## POLICY REPORT DEVELOPMENT AND BUILDING

TO: Vancouver City Council  
FROM: Director of Planning  
SUBJECT: CD-1 Text Amendment: 4500 Oak Street  
(Children's and Women's Health Centre of BC)

4500 OAK STREET  
PROPOSED CONDITIONS OF APPROVAL

4500 Oak Street  
ADDITIONAL INFORMATION

4500 Oak Street  
Form of Development: Child Day Care Facility

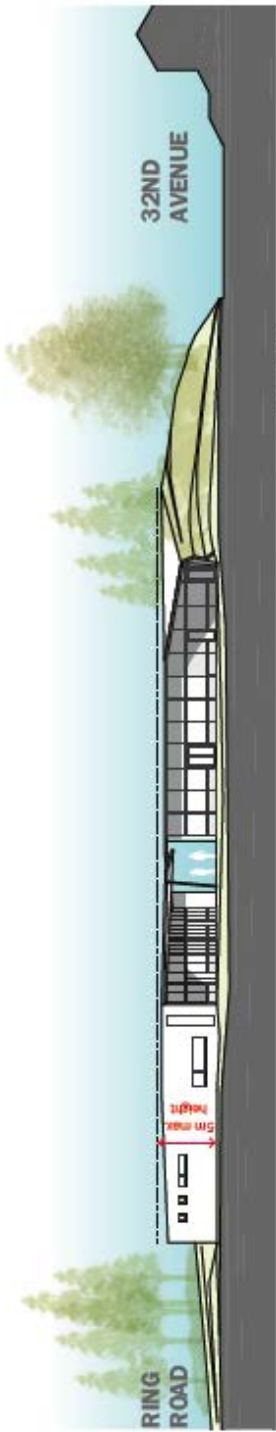
Note to Applicant: See also Engineering conditions.
3. Design development to reduce the projection of the child care structure toward the Wellness Walk, to permit a more generous pathway and landscaped area.

Note to Applicant: Provide at least 7.5 m of width from the building wall to the curb.
4. Design development to visually integrate the landscape and architecture of the child care facility.

5. Design development to better express the main entry of the child care building.

Note to Applicant: Consider opening up the angle of the two entry walls, addition of a canopy over, and other measures to create a welcoming quality for child care users while maintaining access control as required.

6. Design development to the child care building to resolve the details of required guards, fences and other measures to limit unintended access.

Note to Applicant: Details for the roof and play area guards should retain the natural aspects of the proposed design, such as the low, smooth profile of the berm, and reflect the comments of the Urban Design Panel.

- a) The two child day care buildings will be considered as two separate buildings with their own respective principal entrances and fire department connections, as they appear to function as separate from one another.

- d) The Infant/Toddler building will be classified as a Group B, Division 2 building; where children under the age of 30 months are provided with care.

- g) The fire-fighters' path of travel shall be 45 m to the principal entrance to each building and shall be measured from the curb of the building(s) and be 2.0 m clear width.
- h) An accessible curb ramp is required to provide accessible access from the street (Ring Road).
- i) A 2.4 m distance is required to separate combustible projects, such as roof overhangs, that are in close proximity to the adjoining building, or 1.2 m from property lines.
- j) Spatial separation to be reviewed between the two buildings.

4500 Oak Street  
Form of Development: Ronald McDonald House, Main Floor Level

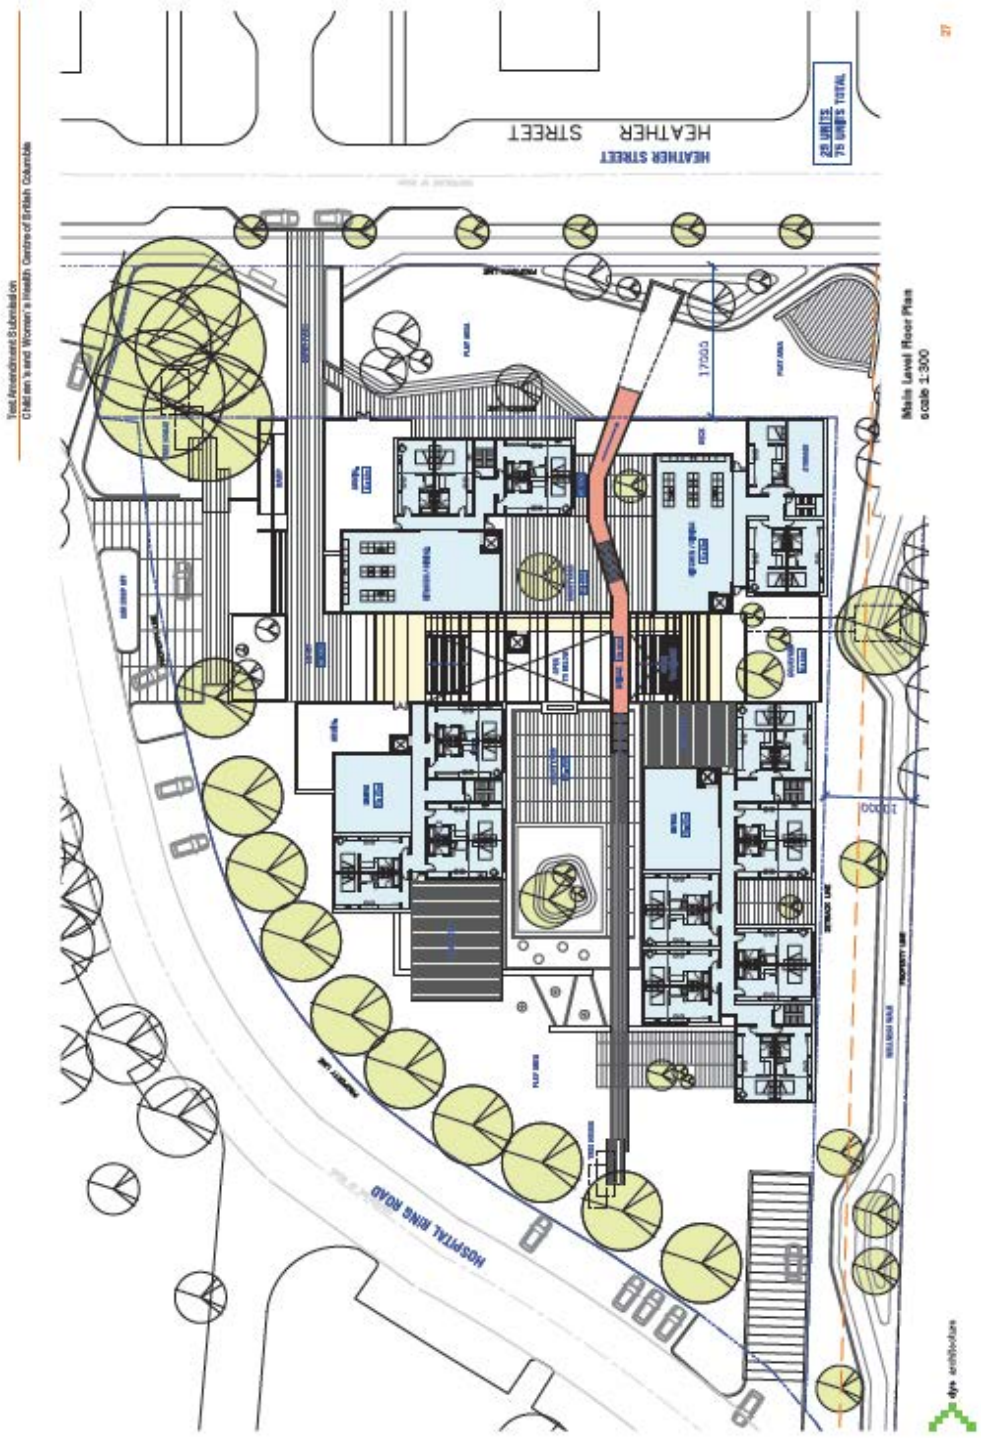
8. Design development to Ronald McDonald House materials palette and detailing to reinforce a residential character.

Note to Applicant: Intent is to avoid an institutional character, such as may be associated with metal walls. See also comments from the Urban Design Panel.

- k) Clarify whether the proposal is a four-storey Group B, Division 2 or Group C building with one level of underground parking. A Group B, Division 2 building is considered a high building (3.2.6.) where it is greater than 3 storeys.

- m) \*Exit stairs that provide egress from another storey cannot have its egress route go through the floor area of the other storeys of the building and must exit directly to the exterior or an approved open space. (Note: Refer to Main and Ground Floor Level Plans)

- p) The drawings do not show an entrance door at the main level entry area to accurately determine whether the exiting system complies.
- q) Large rooms on the ground floor plan may require a second egress door that has an access to an exit door or doors that are sufficiently remote from one another.

- u) Similar to the childcare centre, the fire department connection for this building shall be within 90 meters of a fire hydrant. The location of a fire hydrant shall be located with its maximum distance of 90m as previously described. A new fire hydrant may be required on this site and shall be coordinated and considered usable by Vancouver Fire and Rescue Services if the Ring Road is considered for emergency response. The VFRS may not consider private hydrant to be useable and initial discussion is recommended to ensure adequate coverage is provided.

## 4500 Oak Street Form of Development: Wellness Walkway

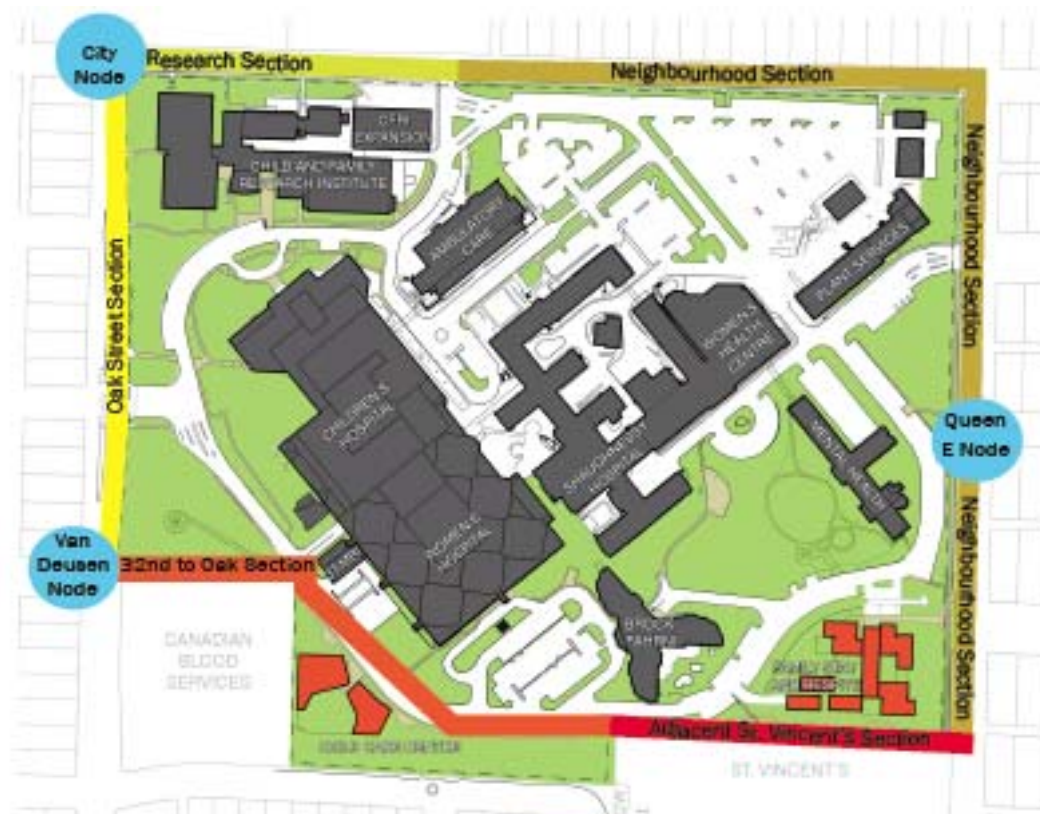
7. Provide a Wellness Walkway, in accordance with the objectives set out in Appendix D, Page 11. (Refer also to Engineering conditions related to securing the Wellness Walkway)

12. Design development to better integrate the landscape around the child care facility into the building design.
13. Details of the proposed Wellness Walkway at  $\frac{1}{2}'' = 1'-0''$  scale or better. (see also condition #20)

20. Provision of large scale ( $1/4''=1'$ ) sections of the three different parts of the Wellness Walkway, indicating path width, materials and the location of trees and other plantings. In addition, provide details and locations for all benches signage, etc. anticipated in these areas. These details should also be reflected in the Landscape Plan.
